**DWR FIELD OFFICE  
APPLICATION FOR APPROVAL  
TO CHANGE THE PLACE OF  
USE AND/OR THE  
POINT OF DIVERSION**

File No. 50461

## SUMMARY ORDER APPROVING APPLICATION FOR CHANGE AND IMPOSING CONDITIONS

Re: Place of Use Change Applications, File Nos. 50461 & 50584 – Marvin Miller

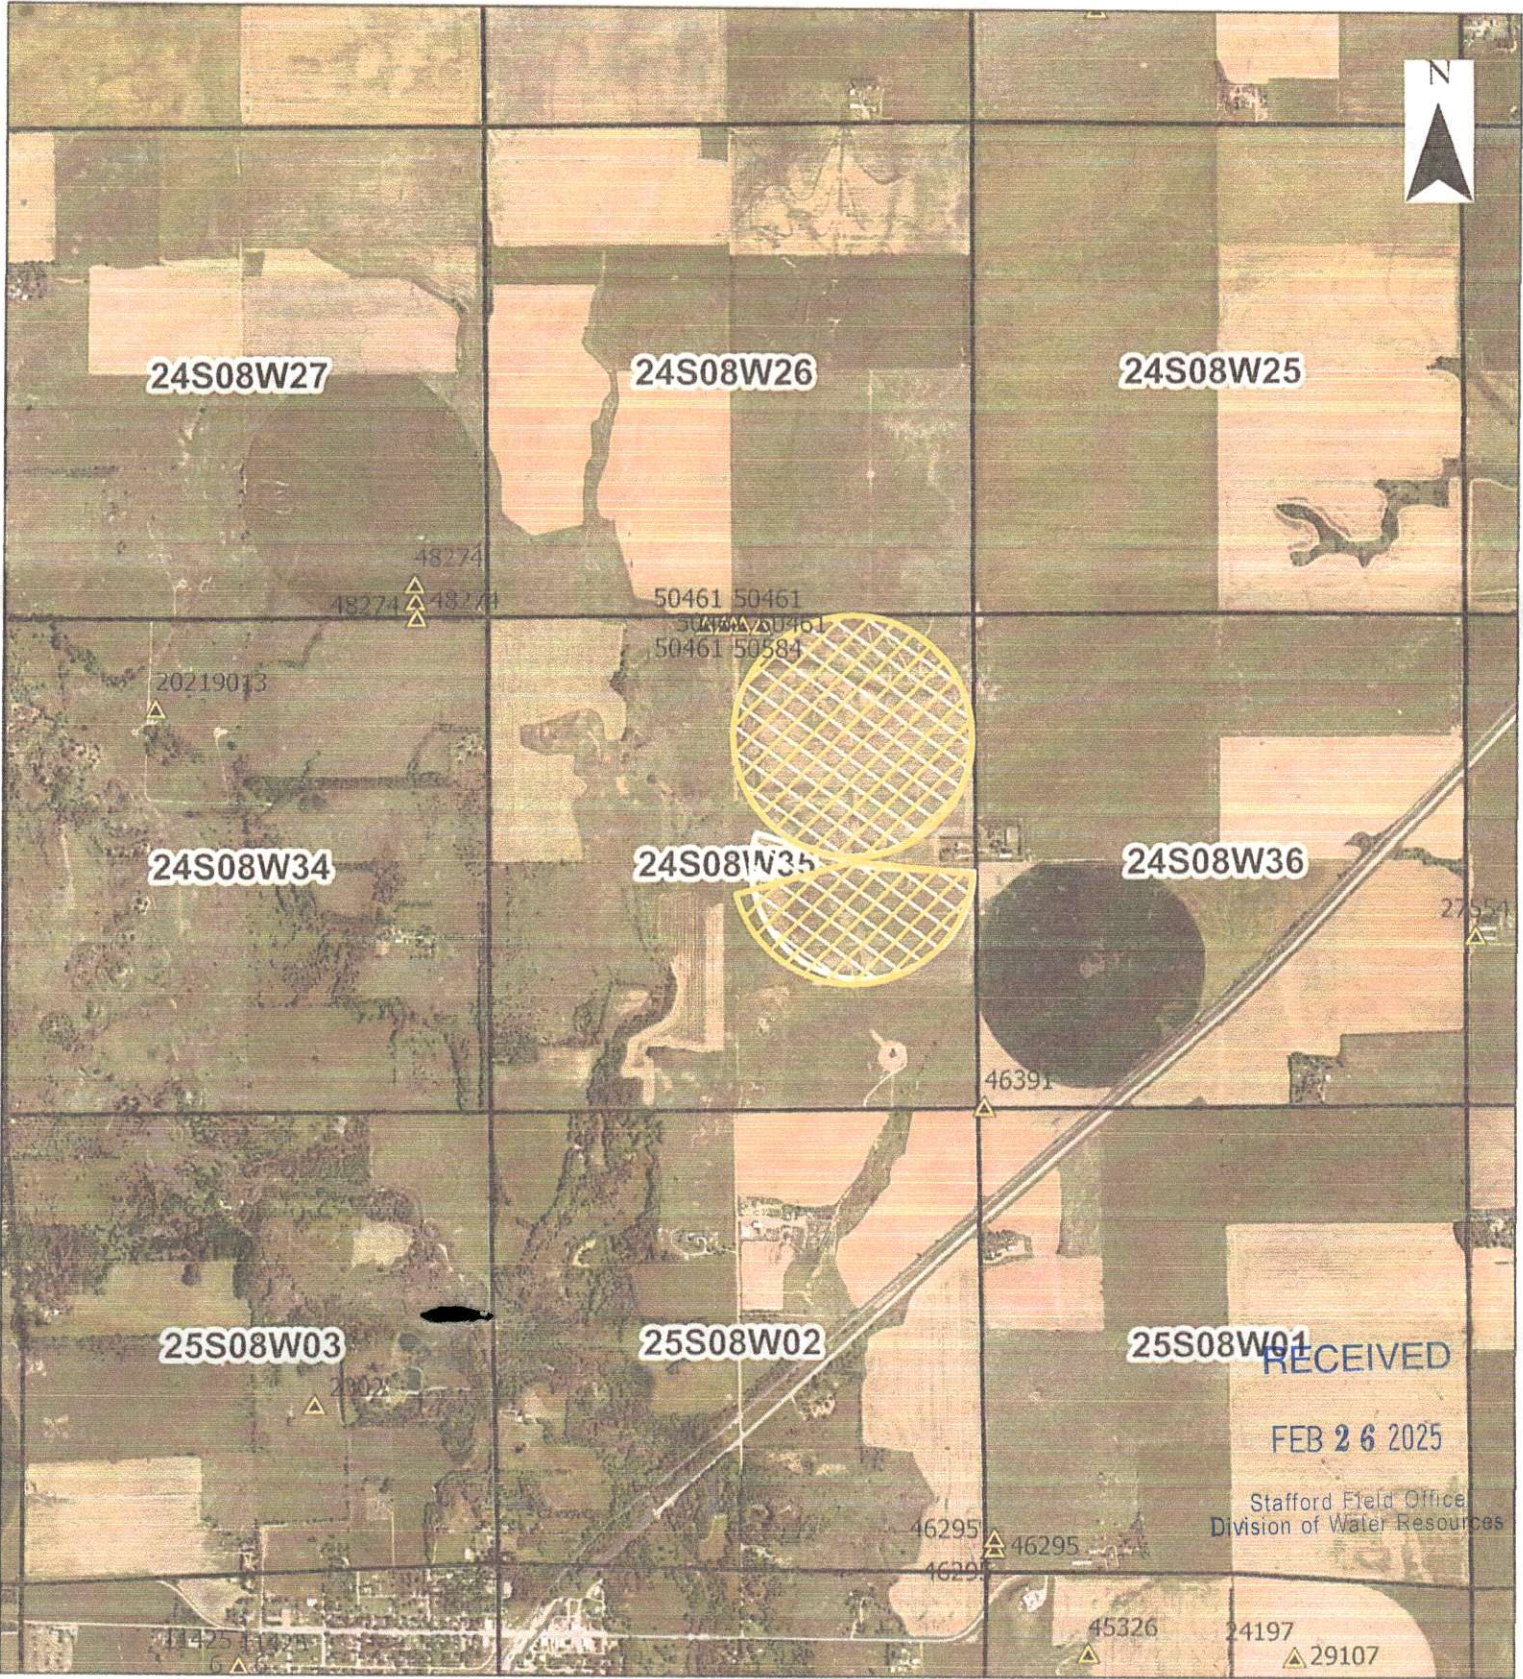
I declare that all water wells or diversions sites using the same source of supply and within 1/2 mile of the proposed point of diversion have been plotted on the application map. \*See Attached page for names and addresses.

- SFFO sections
- Authorized PU
- Proposed Place of Use
- pd
- Half Mile Well Locations
- Domestic Wells

2. On and after the effective date of this summary order, the authorized place(s) of use shall be located substantially as shown on the topographic map accompanying the application to change the place of use. ☒ Applicable ☐ Not Applicable
